MIKE:

- 1) ENGINEERING (DNG) Requires 3 Rope clips
- 2) CROSSY Requires 3 Rope Clips
- 3) SYSTEM Requires LOAD SHARING ON ALL CABLES
- 4) Repair 1 side would require the other side to be Adjusted - to be able to load share all four cables
- 5) if clip pull again - (if installed "to get by") what then?
- 6) with out proper load share; Shunter could drop @ any time. Very Dangerous! who would own liability
- 7) suggestion below low \$ impact, easy to install/fabricate easy to adjust! Would be only 1 rope and 10 clips!

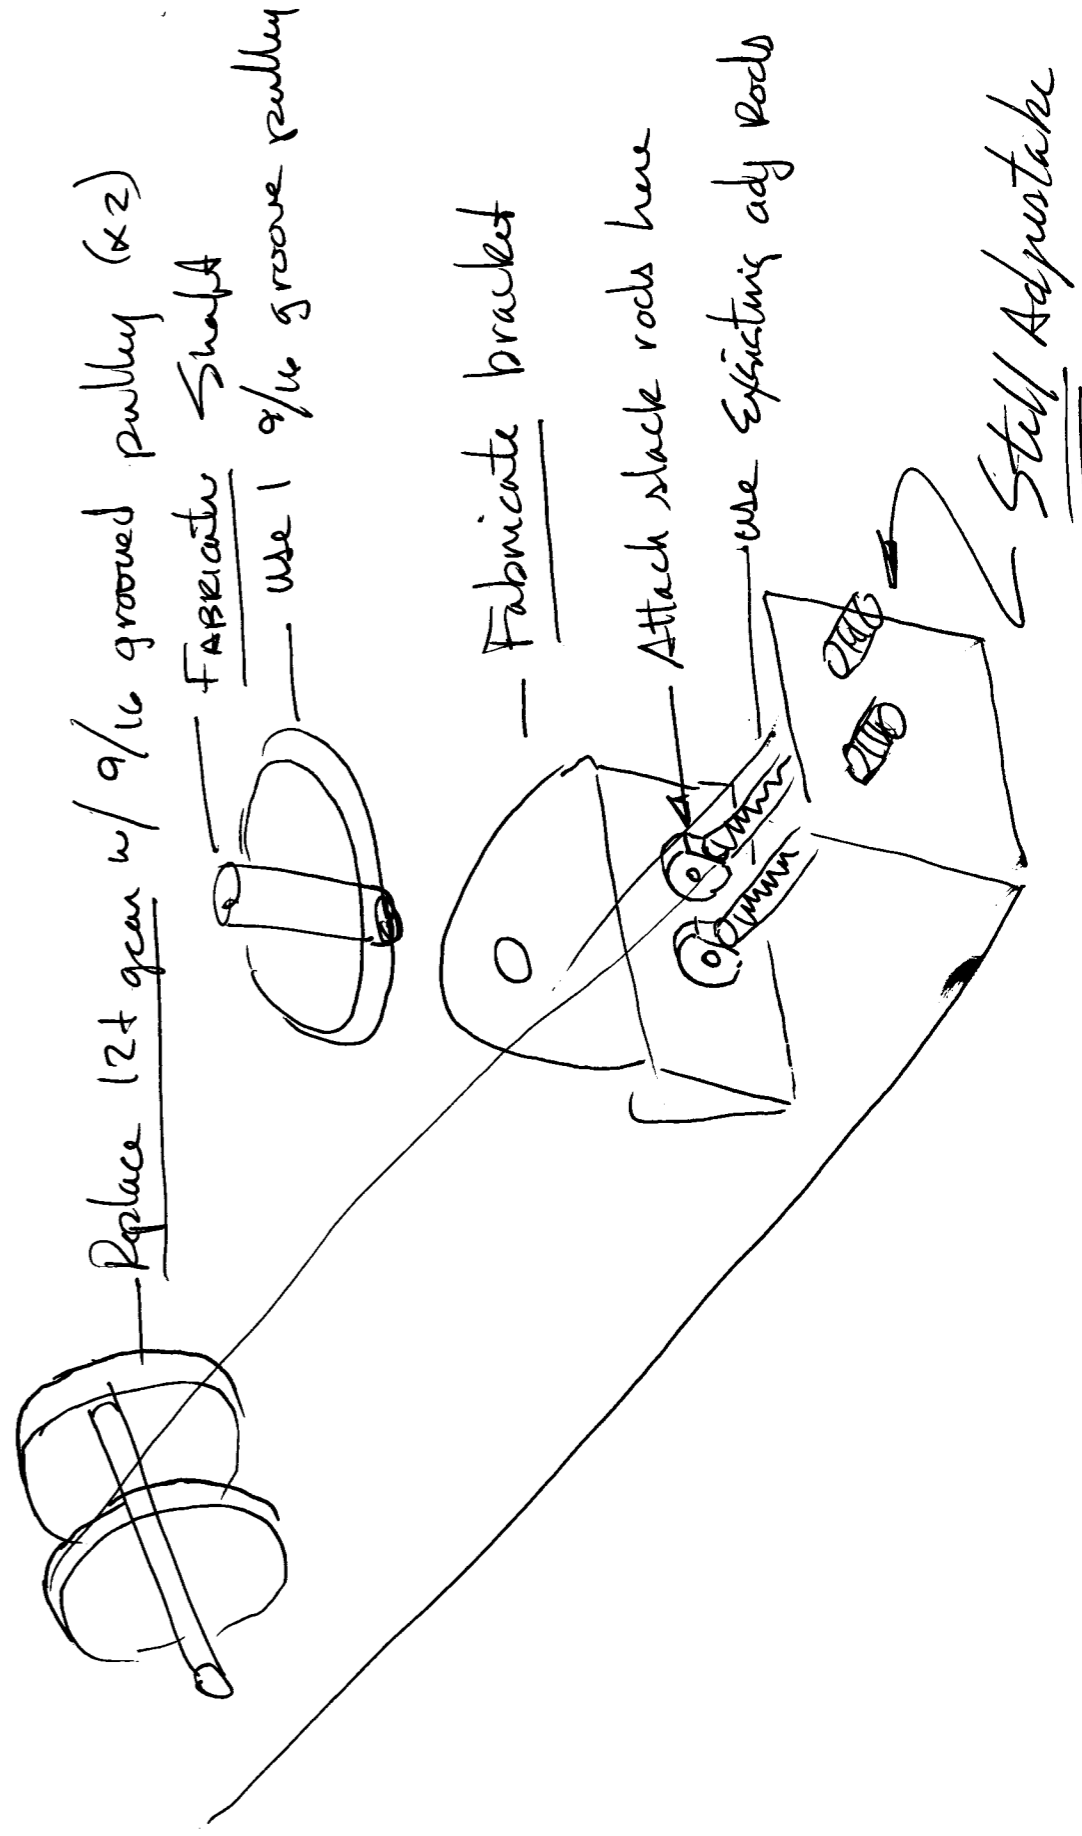
Suggested: 1 rope per side w/ adjust ment

Steel Adjuster
